**Technical Memorandum**  
**Review of Aquifer Project Permit Application**  
**Gunnison Copper Project**

July 27, 2017

Excelsior Mining Arizona proposes to construct an in-situ leach and recovery copper mine near Dagoon, Arizona. This technical memorandum reviews the Aquifer Protection Permit Application for the Gunnison Copper Project.

**Figure 3: Figure 123 from CCA (2016) Appendix G showing the relation of hydraulic conductivity with azimuth between pumping and observation wells.**

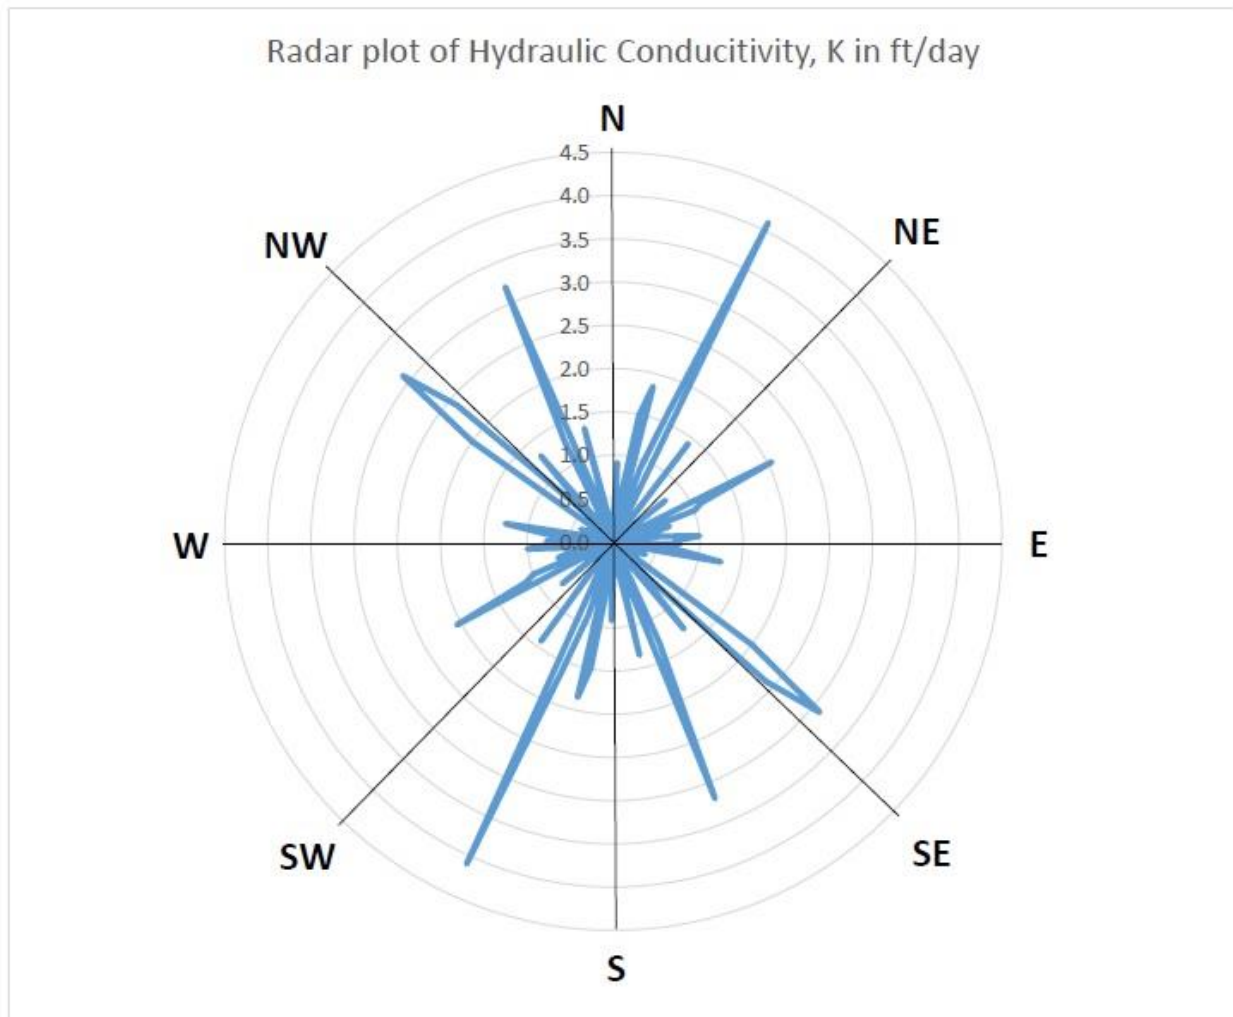
Appendix G presents a directional plot of conductivity with azimuth, which they claim shows they can average the K values without considering direction (Figure 3). Rather than showing “that the hydraulic conductivities are relatively evenly distributed with little prevalent direction” (Appendix G, p 31), Figure 3 shows a substantial correlation with direction. This is especially true for a direction from midway between north and northeast and between south and southwest, where the K exceed 4.0 ft/d, and for a roughly perpendicular direction along

which K is just over 3.0 ft/d. Additionally, between those transverse K trends, there is another line of about 3.2 ft/d trending from between north and northwest to between south and southeast. K in other directions is less than half as much. The trends show a perpendicular fracture pattern, but does not demonstrate that “the fracture patterns intersect sufficiently at the well spacing of 100 feet to smooth out, for the purpose of hydraulics, discrete fracture spacing which is on the order of one foot” (Appendix G, p 31). There is nothing in the Appendix, or anywhere in the Application, that indicates the spacing of the intersection of fracture patterns or of one-foot discrete fracture spacing.

- Excelsior should consider horizontal anisotropy in its modeling and project design. The effects of not considering this are better considered below in the discussion of modeling.

**Figure 4: Figure 5-9 from Clear Creek Associates (2017a) showing the wells and coreholes with petroleum hydrocarbon hits.**

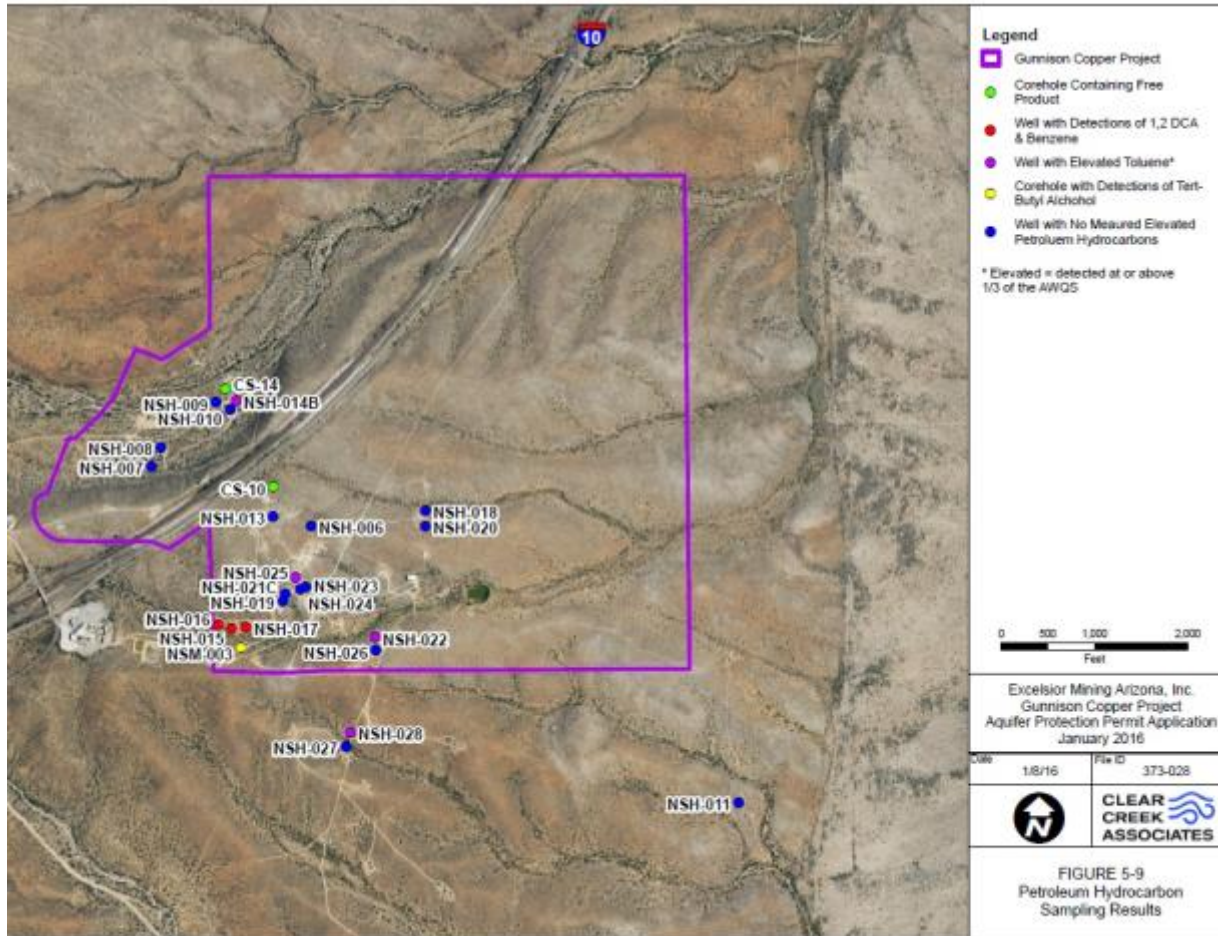
different hydrocarbons, as seen by the distribution of hydrocarbons in Figure 4, may reflect different transport and attenuation rates for the different products within the fracture zone affected by the source. The intermixed wells without any hits may be screened in different fracture zones.

- Due to the importance of understanding the source of petroleum products, Excelsior should reconsider the potentiometric surface map to consider whether the water levels used for mapping all represent the same aquifer level. In a fractured rock aquifer, it is not often appropriate to assume there are no vertical gradients. The map with water level with respect to the top of the bedrock (Figure 5-12, CCA 2016a) shows significant variability in small areas, suggesting that it is possible the water levels represent different bedrock levels. It is possible that groundwater flows southeast from the mine at certain levels. For this reason, the mine cannot be ruled out as a source.
- Hydrocarbons in the groundwater could affect the chemistry of the project. Excelsior must complete a larger survey of the LNAPL contamination and assess whether and how it could affect ISL operations.

**Figure 5: Figure 5-10 from Clear Creek Associates (2016) showing the potentiometric surface at the site and to the west and northwest.**

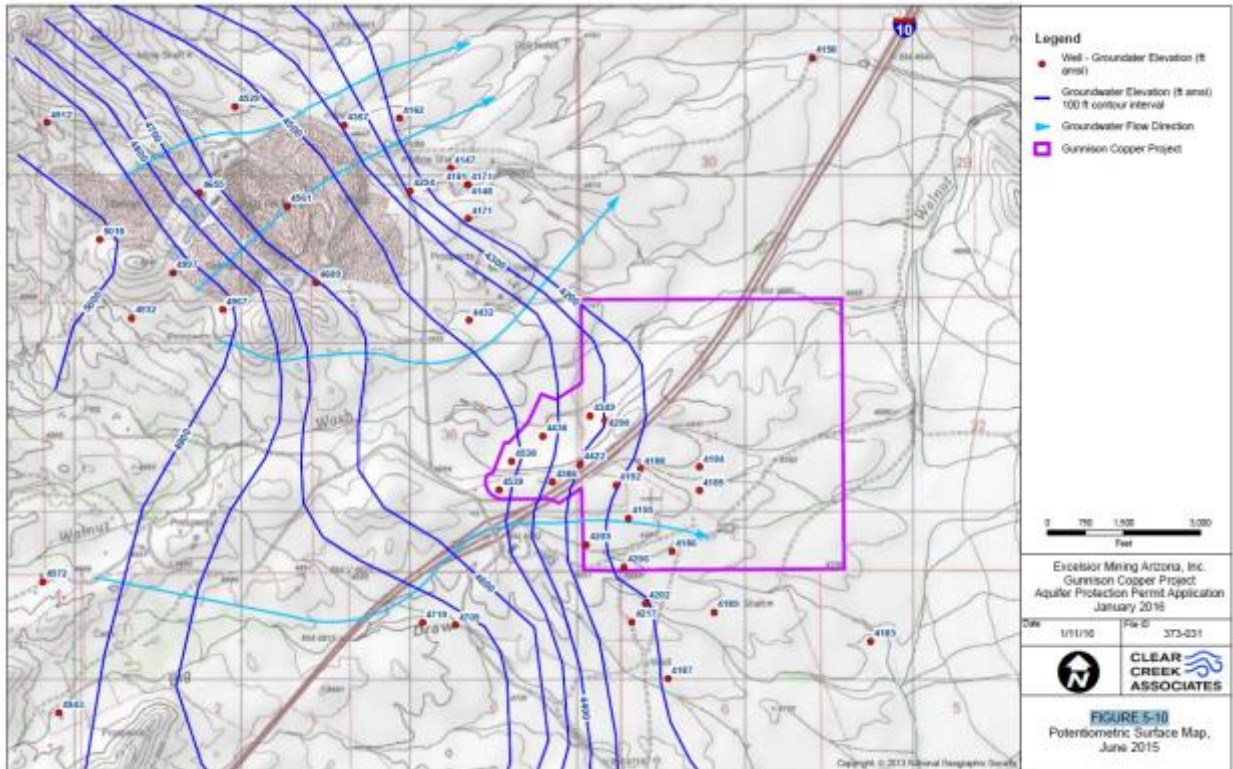
As noted, the mine apparently did not use gasoline, so Excelsior seems convinced that it could not be a source (CCA 2016, p 5-9). They also point to the gradients of the potentiometric surface which suggest that groundwater flow from the mine would be to the northeast and would miss the project site by a mile or more. The potentiometric surface (Figure 5) appears to drop steeply northeast of the mine and appears to form a ridge on the west side of the project site.

**Figure 7: Figure 5-16 (CCA 2016) showing the point of compliance wells, observation wells, and hydraulic control wells.**

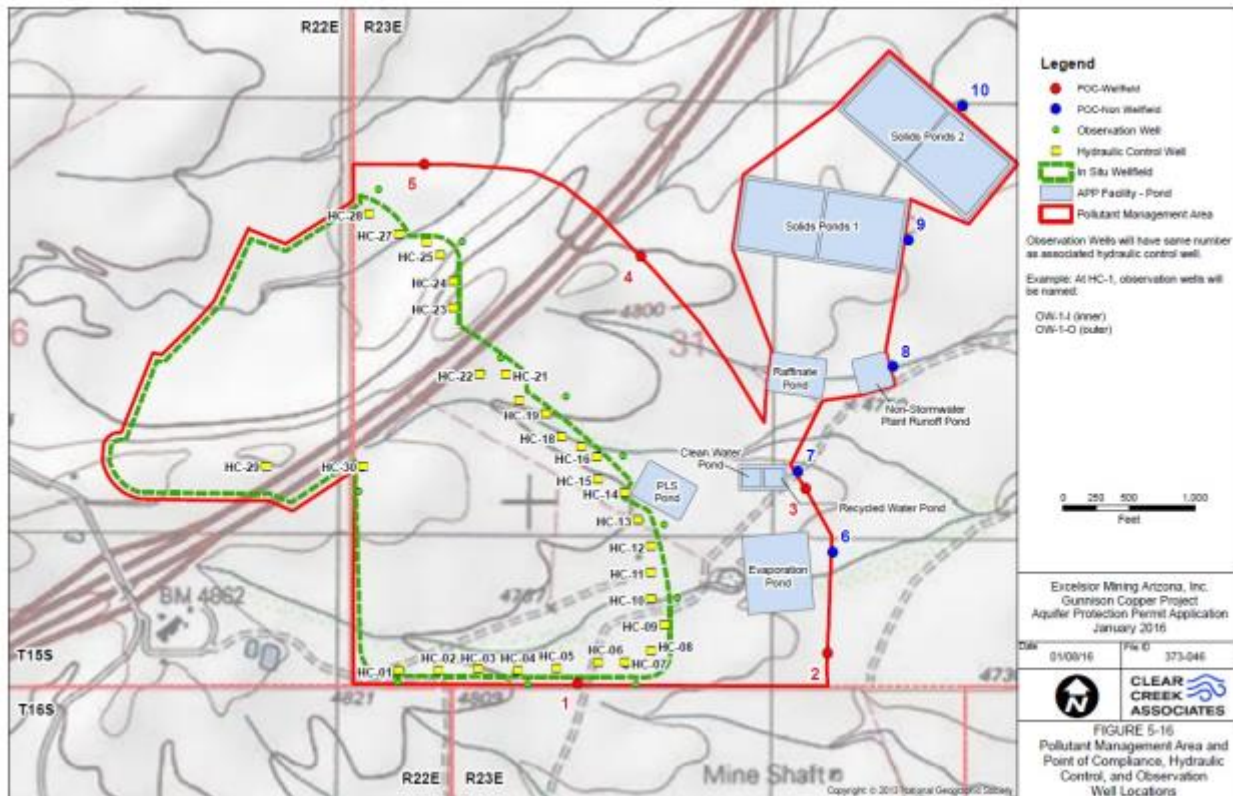
Excelsior proposed five POC wells located outside the area of review (AOR) (CCA 2016, p 5-18) (Figure 7). The AOR is roughly the hydraulic barrier created by the hydraulic control wells. The five POC wells are grossly insufficient for two reasons. First, the wells would be “screened in bedrock, with the top and bottom of the screen set at approximately the same elevations over which the injection wells are open”. This would ultimately be a screen over hundreds of feet, which is grossly insufficient to detect contaminants moving off of the site. Contaminants escaping the site would follow preferential flow pathways, so even if the screened intervals intercept the flow paths, the contaminants would be highly diluted by mixing with groundwater higher and lower than in the aquifer.

Second, five wells spaced along the pollution management area perimeter (Figure 7) is grossly insufficient spacing. Large contaminant plumes could flow between the wells undetected. Also, their placement assumes the potentiometric surface gradient is adequately known to be sure there could be no movement to the south, north, or even west. This is an unsupported assumption because, as discussed elsewhere, heterogeneities and preferential flow paths could cause flow paths that are not perpendicular to the general contours.

There would also be five POC wells downgradient of the impoundments (Figure 7), intended to detect leaks from those impoundments. POC wells 9 and 10 would monitor along the downgradient side of solids ponds 1 and 2. Having just one well for each of these ponds is insufficient because they would only detect contaminants that leak into a flowpath directly upgradient of the well. The size of these ponds should make obvious there are many areas that could contribute contaminants that would not be upgradient of the POC well. These POC wells would detect contaminants that reach the water table through the unsaturated zone, so the source would be at the water table. They would disperse vertically, but not that deeply. The wells should screen the water table and extend below the water table the minimum possible to be sure that water table does not fall below the well. The 60-foot proposed screen thickness is far too large to adequately detect contaminants at the water table because it would allow for cleaner, deeper water to dilute the contaminants.

There would be OWs included on the site, as shown in Figure 7. However, the draft permit and the application refer to observation well pairs (Draft Permit, Table 2.5-2), but none of the figures show enough detail to show what a “pair” means. They are intended to show that the hydraulic control wells are maintaining an inward gradient. There are insufficient OWs shown in Draft Permit Table 2.5-2 to show the gradient at each hydraulic control well. The observation wells are insufficient for proving the maintenance of an inward hydraulic gradient, as described in the Draft Permit, section 2.6.2.4.3.

- The number and spacing of POC wells should be determined by modeling of contaminants being released either within the well field or the ponds accounting for horizontal dispersion. Well-spacing should be less than the width of simulated plumes at the line of POC wells.

- The POC wells downgradient from the well field should monitor different vertical preferential flow paths separately. That means that at each POC well location, the wells should monitor each potential flow zone. Either nested wells or multiple opening wells could be used. Multiple screened openings along the bore hole no more than 20 feet long would be preferable so that the depth of the contaminant could be determined.

- The POC wells below the ponds should span the water table to adequately monitor contaminants that could reach the water table. The screen length should be the minimum possible to avoid the water table dropping below its bottom

- POC wells should extend along the north and south boundaries, with some buffer as established on the east side, to assure that contaminants do not flow in unpredicted directions.

**Figure 10: Figure 15 from CCA (2016) Appendix I showing the geologic and fracture intensity model.**

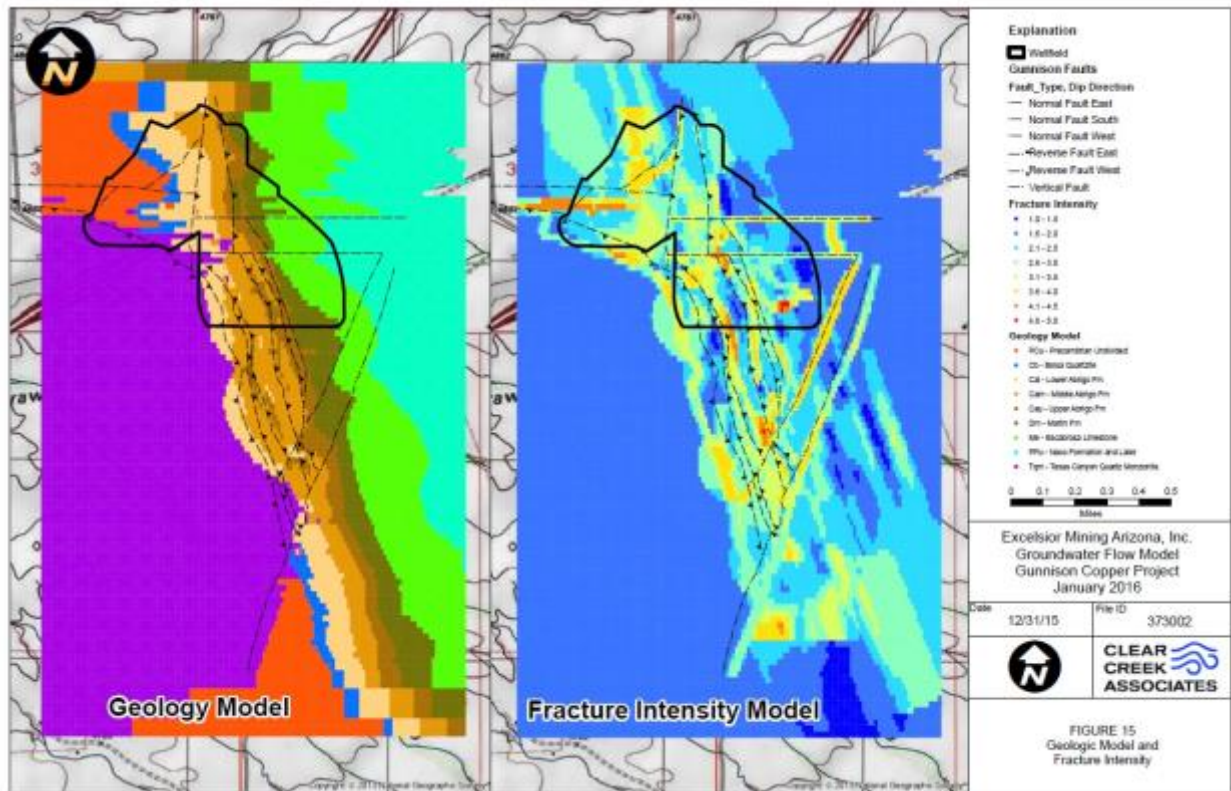
The fracture intensity is much higher in the areas with significant faults, as shown on Figure 10. Faults trends just west of north through the domain south of the project site and curve to a more northwest trend near the site. The yellows and reds on the fracture intensity model is the area of higher fracture intensity. Fracture intensity is much lower west and east of the project

area. A model fit shows that conductivity ranges from 1 to about 10 ft/d for the higher fracture intensity (Appendix I, Figure 16).

*Figure 11: Magnified portion of Appendix I, Figure 22 showing the details of the parameter zones on the west side of the ore body, and to its south.*

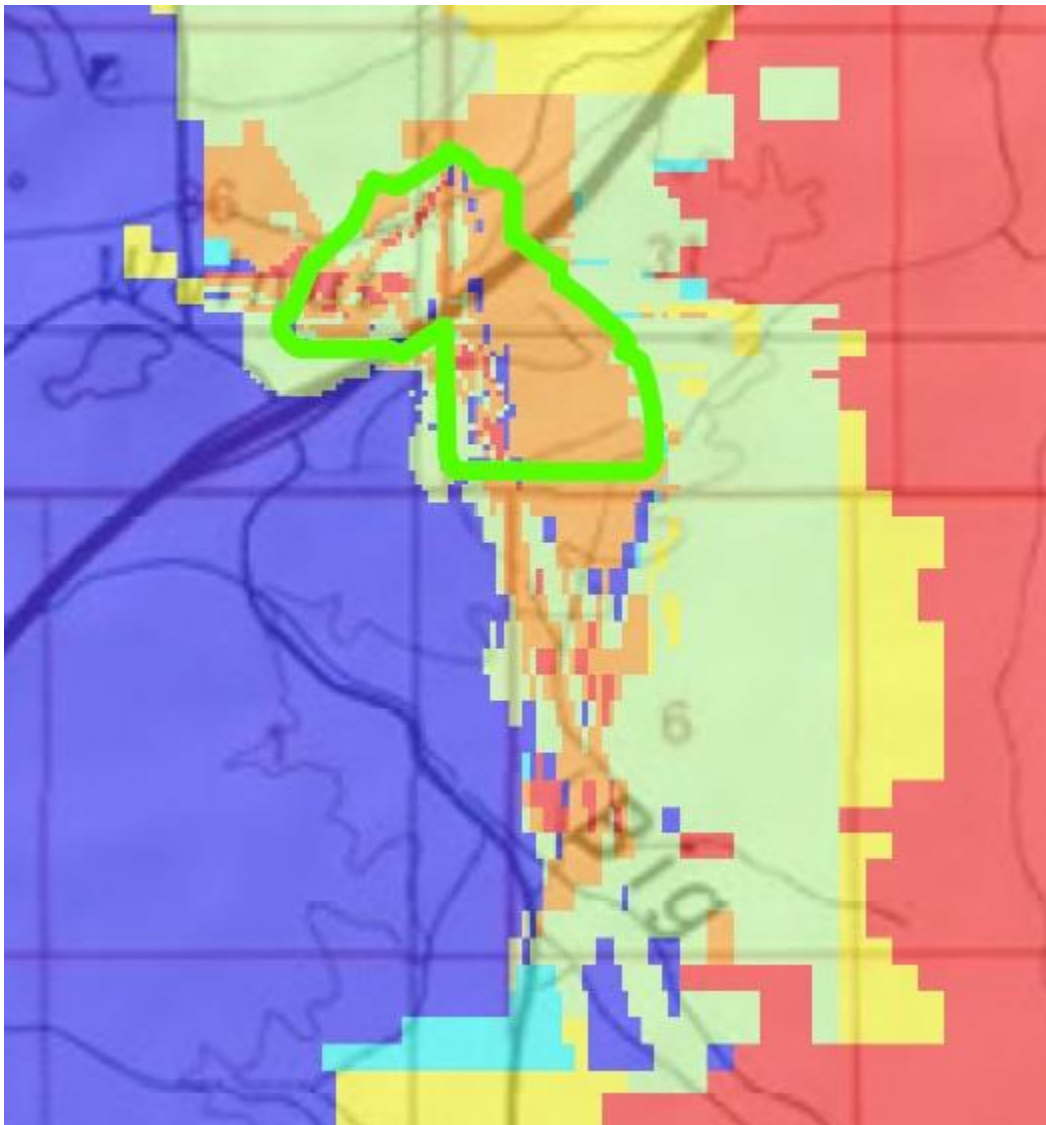
Because of the fracture intensity modeling, the model has very detailed parameter zone models within the ore bodies, as can be seen from detailed observation of the ore body on the parameter zone maps for each model layer (App I, Figures 21 -27). Most of the well field area has  $K$  equal to  $0.5$  to  $1.0$  ft/d, with some intermittent higher and lower cells that resulted from the detailed fracture intensity modeling. The west half of the ore body has the most detailed parameter zones, as may be seen in the magnified portion of App I Figure 22 shown in Figure 11

for layer 2. The complicated fracture intensity model may represent the fractures associated with faulting, as shown in Figure 10.

**Figure 12: Figure 32 from CCA (2016) Appendix I showing the calibrated steady state recharge rates around the model domain.**

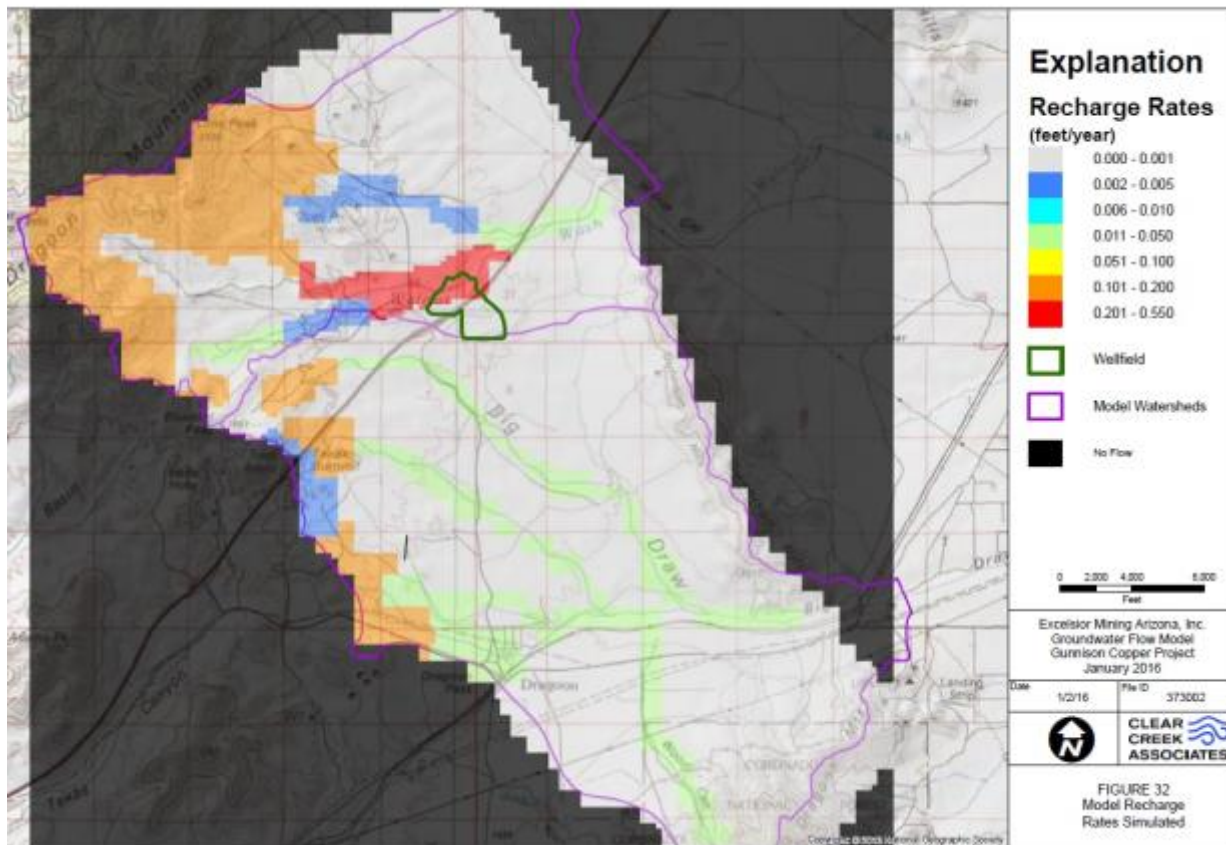
As part of calibration, the modelers distributed the total recharge around the model domain (Figure 12). The noncolored area on Figure 12, which is most of the domain away from the mountains and washes, represents recharge less than 0.012 in/y.

The concentrated recharge may significantly bias the model results. The large zone in orange, west of the project site in the Little Dragoon Mountains, is recharge from 1.2 to 2.4 in/y (Figure 12). Recharge would enter the groundwater in this mountain block only if the geology is highly fractured at the surface, otherwise the area should mostly generate runoff. Much of those mountains have the second highest conductivity values (Figure 13), possibly due to the calibration.

Walnut Wash is a substantial drainage which flows east from these mountains, which indicates there is substantial runoff from the mountains. The model simulates from 0.55 to 6.6 in/y near Walnut Wash west of and within and north of the north quarter of the wellfield. The area is almost 2000 feet wide and over 6000 feet long. The recharge rate into the model domain through the Walnut Wash area is very high, the product of the rate and area shown in red. Most other areas that represent washes are simulated with recharge from 0.12 to 0.5 in/y (green).

Only the smallest recharge rate is used for recharge in the Dragoon Mountains in the southeast. Even if the geology is not conducive to distributed recharge, there should be runoff that leads to mountain-front recharge.
